Addenda No. 3

Window & Door Replacement at JG Simcoe Public School

RFQ 22-04

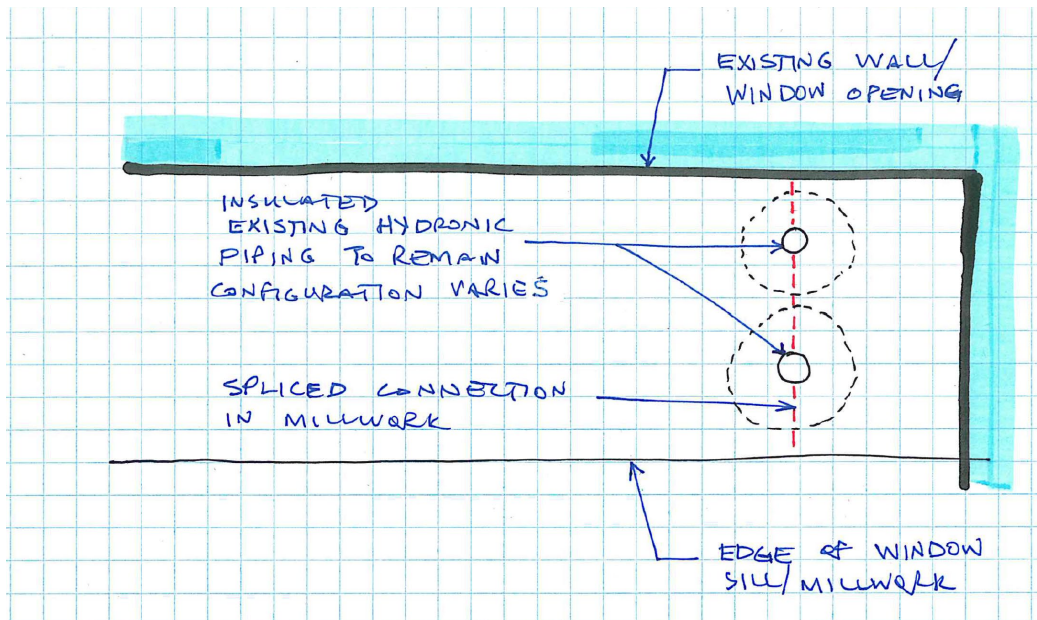
Please confirm if we have to carry a pre-qualified mechanical subcontractor to drain, cut, re-install, re-insulate refill and re-start the hydronic system. Please confirm the number of pipes shown on the document is accurate. Please confirm the diameter and nature of pipes to be cut.

As a result of internal discussions, the scope of work related to disconnection and reconnection of the hydronic piping is being deleted from the scope of this project. In order to install the millwork counter/windowsill, the contractor will be required to splice the countertop down the center of all penetrations in order to sandwich the penetration. Existing vinyl wrapped pipe insulation is to be removed and replaced as required to complete the work. Refer to following sketch.
